Draft Class VI Well Permit, Marquis Carbon Injection, LLC

Pam Richart, Eco-Justice Collaborative

Figure 2-105: Map showing the 29-mile AoR, and existing and proposed project deep wells that penetrate the confining layer within the AoR. Well data is summarized in Table 2-18.

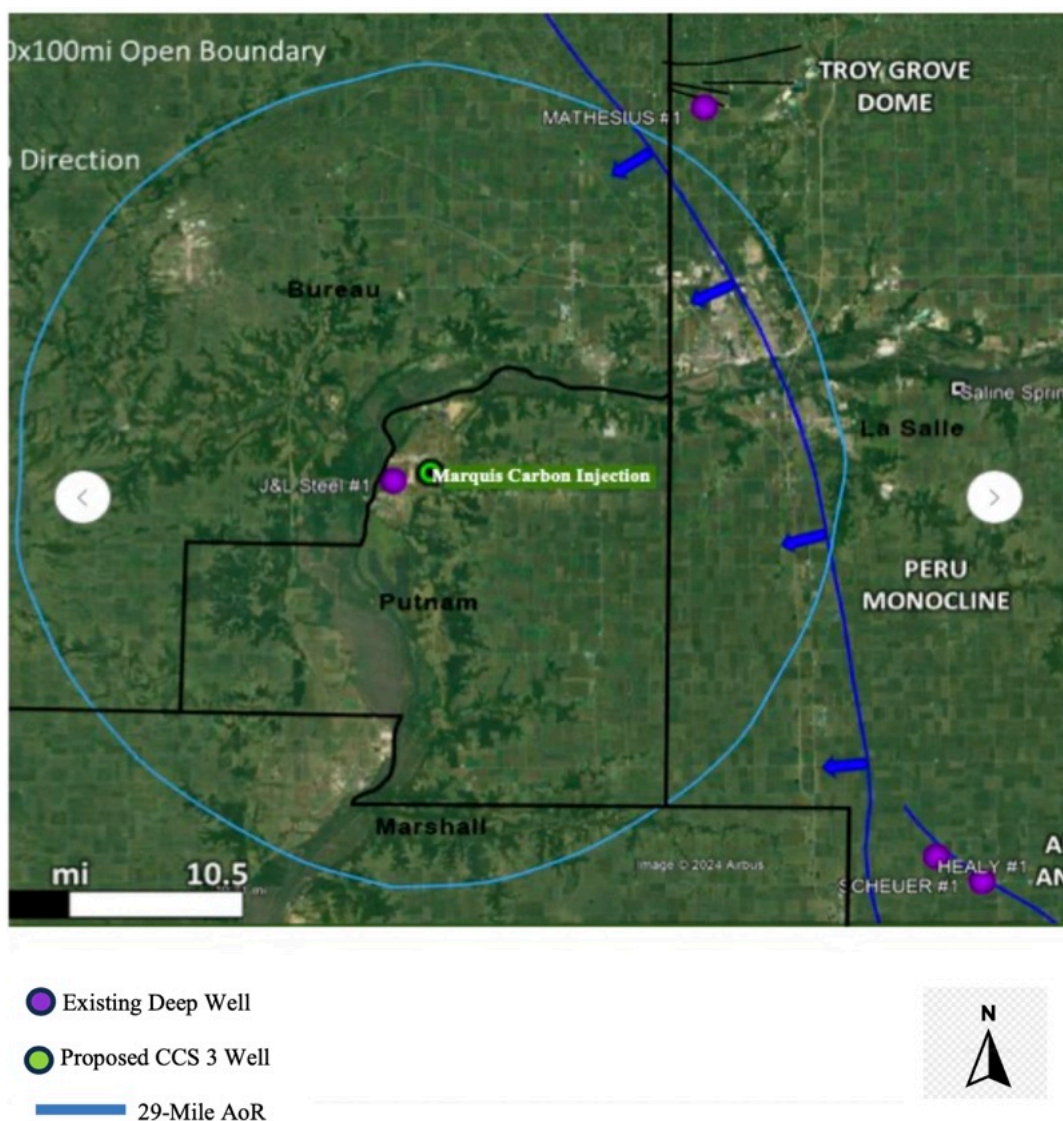
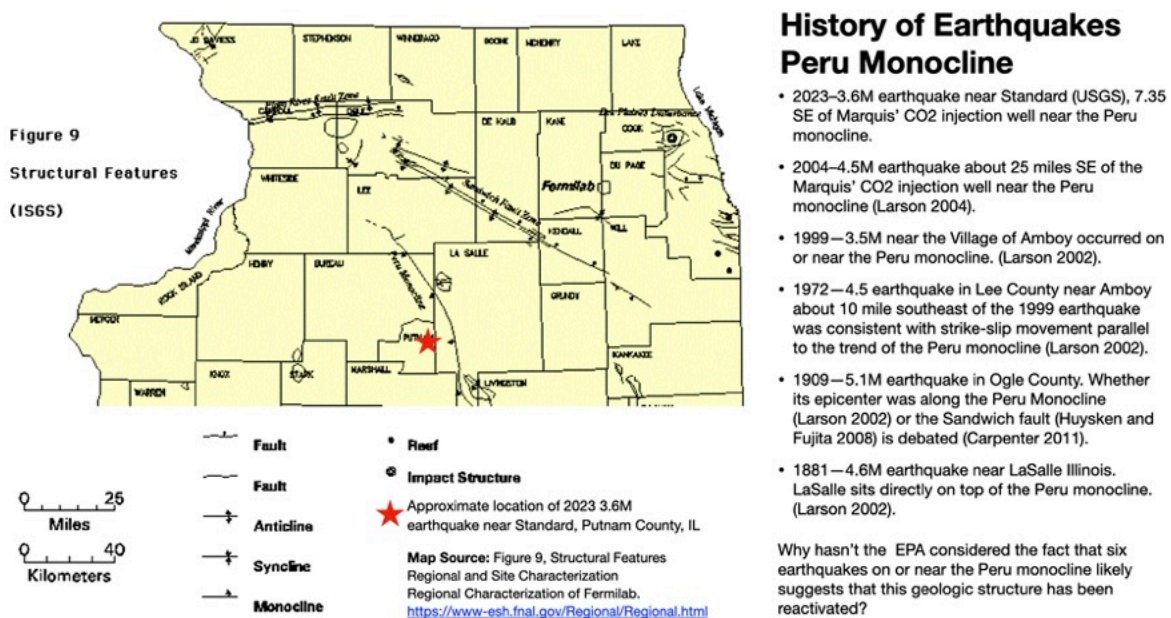
As shown on this exhibit, prepared by Marquis Carbon Injection, LLC the Peru Monocline runs through the eastern edge of the project's AoR.

Data provided in Marquis’ project narrative omits conclusions reached by Timothy Larson, ISGS, and others: the Peru monocline that passes through the AoR may have been reactivated.

1. Why didn’t Region V take into consideration that the Peru monocline may have been reactivated and could cause future earthquakes that could affect the confinement of CO₂?

2. Isn't the analysis by geologists regarding the reactivation of the Peru monocline a reason to require the injection well to be relocated and/or additional studies identified in the Class VI guidance related to seismic history, modeling, and fault stability analysis to be carried out (see pages 4 and 5, below)?

Figure 17. Zoback and Hennings 2025.

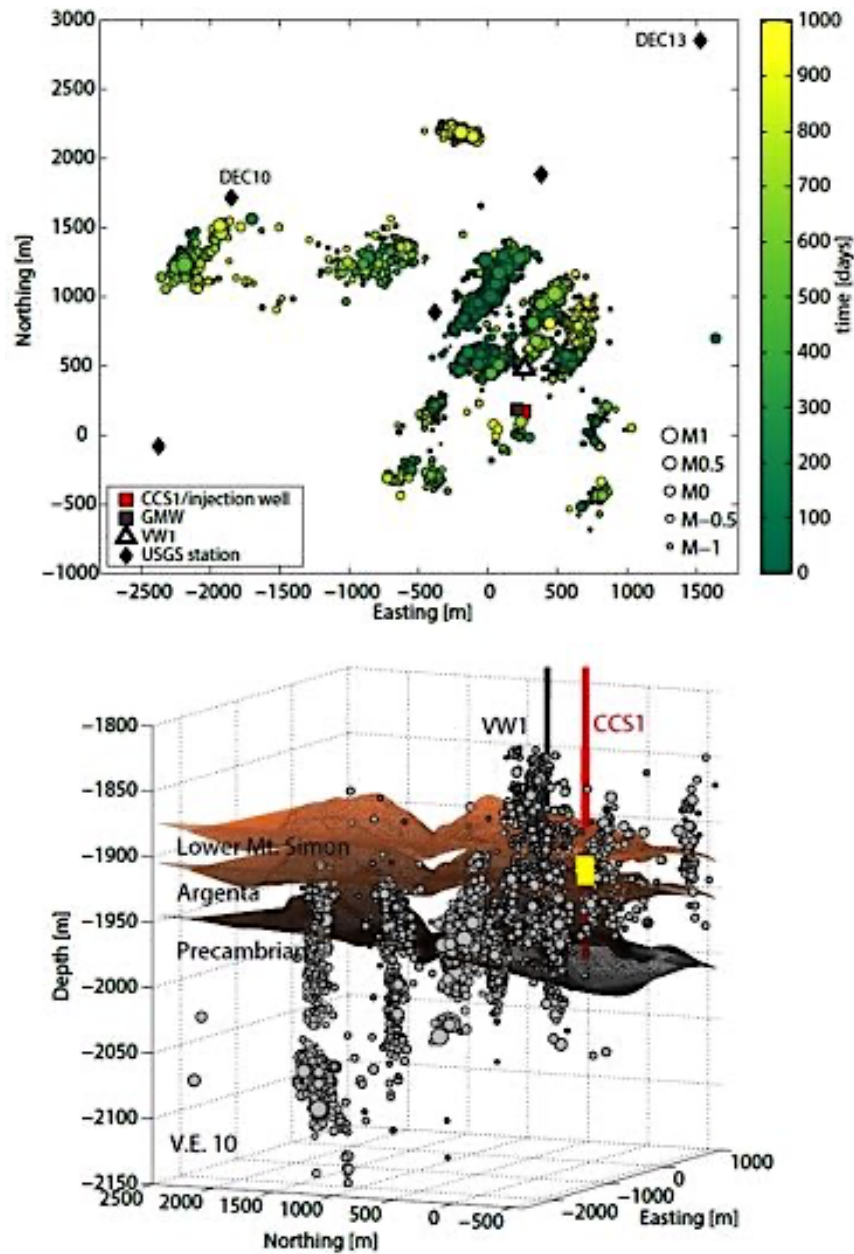
This study recognizes the relationship between the magnitude of triggered seismicity and that even with relatively small-scale CO₂ storage projects, such as ADM's Decatur CCS#1 and CCS #2 projects, have not yet been tested. What could happen if larger volumes of CO₂ are injected into the Mount Simon? Will there be adequate hydrologic barriers separating the injection zone from the basement? This question applies to the Marquis Carbon Injection project, which, like ADM Decatur's CCS#2, would maintain barriers separating the injection zone from the basement. Other questions that need to be addressed include:

1. If the Peru Monocline can cause earthquakes that range from 3.5M to 5.1M, could the injection of 1.5 MMT CO₂ trigger earthquakes at the same magnitude—or perhaps even

2. Will Region V consider [Zoback and Hennings 2025](#) findings in their analysis of seismic activity and the potential to trigger earthquakes that could be large enough to damage the well or fracture the cap?
3. If not, why not?
4. Does the scale of injection proposed in Illinois raise concerns for Region V (see EJC Figure 2, above)? Shouldn't the potential for additional storage in the area surrounding Marquis Carbon Injection's first CO₂ storage project be considered, particularly in light of the fact they are considering injecting on properties located to the west? See evidence of Marquis' proposed expansion in [SB1550, introduced by Senator Sue Rezin](#) in 2023.

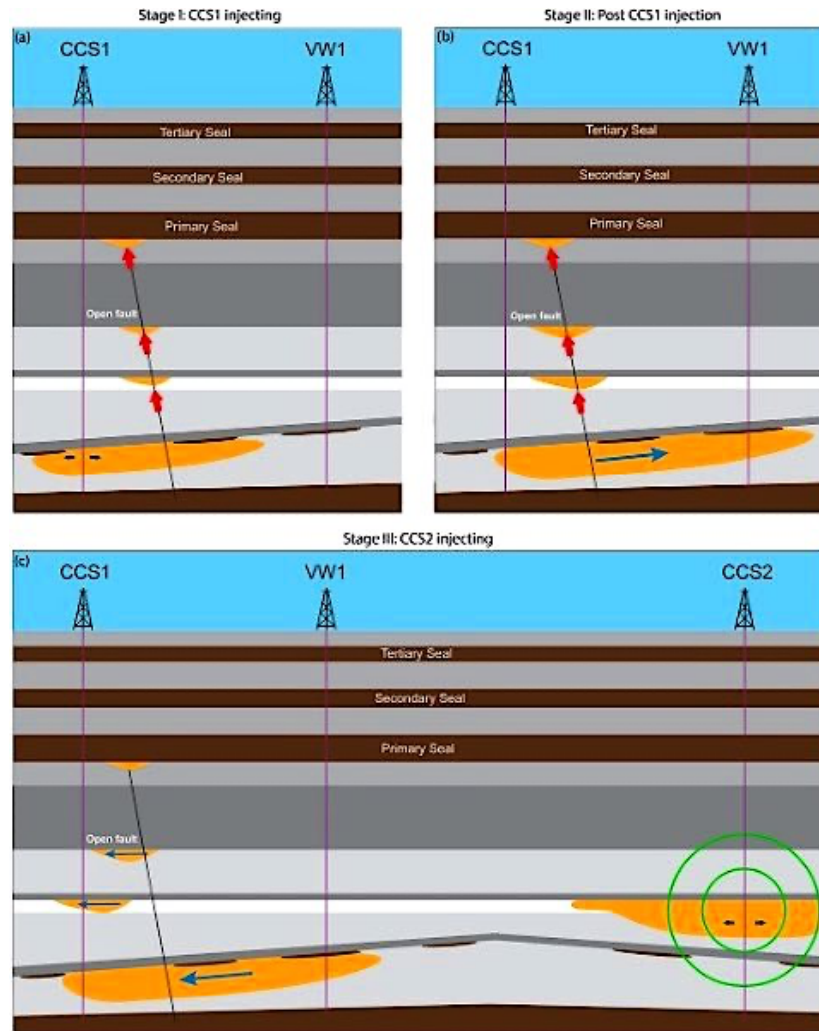
We know geologic structures that exist in the Illinois basin are not limited to the Wabash Valley and New Madrid Seismic Zones. This includes the Peru monocline that passes through the eastern part of the AoR and extends both to the north and south which may have been reactivated ([Larson 2002](#)). [Buker et. al 2025's](#) use of time-lapse seismic surveys at the Illinois Basin—Decatur Project reviewed by Harvey showed that the CO₂ plume migrated along major faults very soon after injection began, entering upper units of the reservoir and moving laterally in response to injection at a neighboring site. In fact, they show that the CO₂ must have migrated rapidly from the injection interval up the faults to the Upper Mt. Simon, covering a vertical distance of about 350 m in 4 months or less. This puts the vertical migration speed at a minimum of 3 m per day!

These observations emphasize the importance of considering faults associated with Marquis's project as potential flow pathways, as well as the impact of pressure from their planned injection sites on the west side of the Illinois River on plume dynamics. This work underscores the need for more rigorous modeling of the potential influence CO₂ injection will have on plume dynamic behavior in the area of known faults.

Figure 1-4 from Marquis Carbon Injection, LLC February 2025 Project Narrative: Map showing the modeled CO₂ plume footprint, and existing and proposed project.

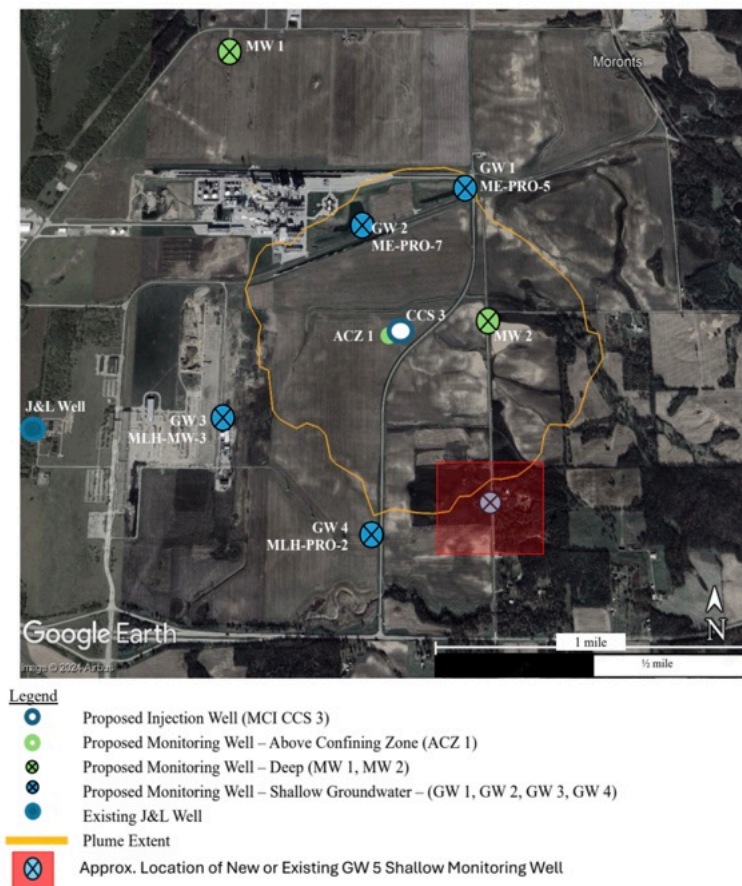
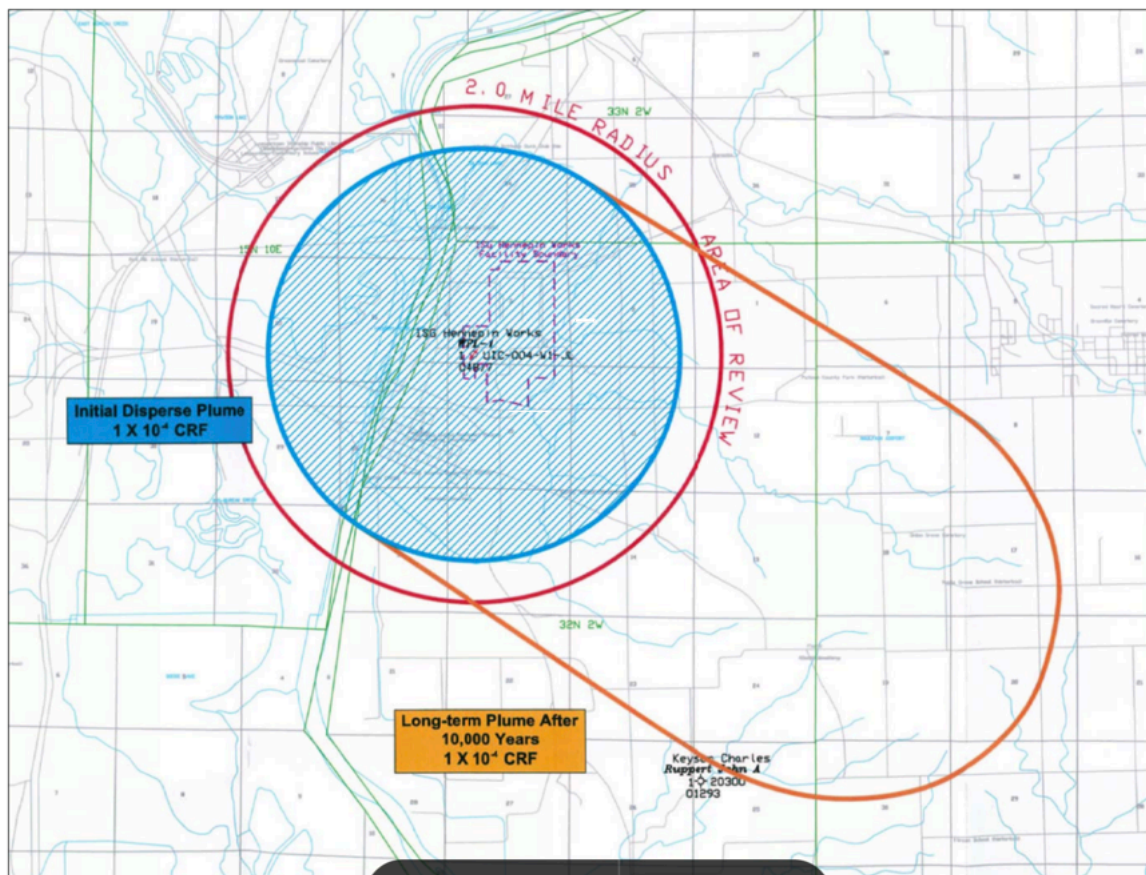
Given the unpredictable behavior of CO₂ the potential for natural or triggered seismicity, and the proximity of the J&L pickle liquor waste well to the modeled CO₂ plume, EJC believes that the proposed project greatly endangers a USDW. This is because a seismic event could affect containment of the pickle liquor well waste in addition to the confinement and permanent storage of CO₂; and the CO₂ and the highly toxic pickle liquor waste could intersect, creating a highly toxic environment that could degrade the existing J&L injection well and the planned CO₂ injection well.

The lack of a deep monitoring well between these two wells, which are separated by just 1.3 miles also is a concern. The nearest deep monitoring well is 1.6 miles from the J&L well and 0.3 miles east of the proposed CO₂ injection well. There is no plan to continue monitoring the J&L well, despite the fact that the modeled CO₂ plume appears to intersect with the J&L pickle liquor waste well plume, which has a two-mile radius (see Figure 1-4 from Marquis' Project Narrative and the AoR of the J&L well, below.

3. Why hasn't REGION V required a monitoring well to be located between the two injection wells? This is the only way to identify, in a timely fashion, leaks that might occur from corrosion or the possible intersection of the two plumes that might occur from outside forces. This could include seismicity, or movement of the CO₂ plume due to pressure, or anything else that might occur to affect confinement of these toxins. A deep monitoring well located over a mile from the J&L pickle well is insufficient to detect changes that might affect confinement of either waste.
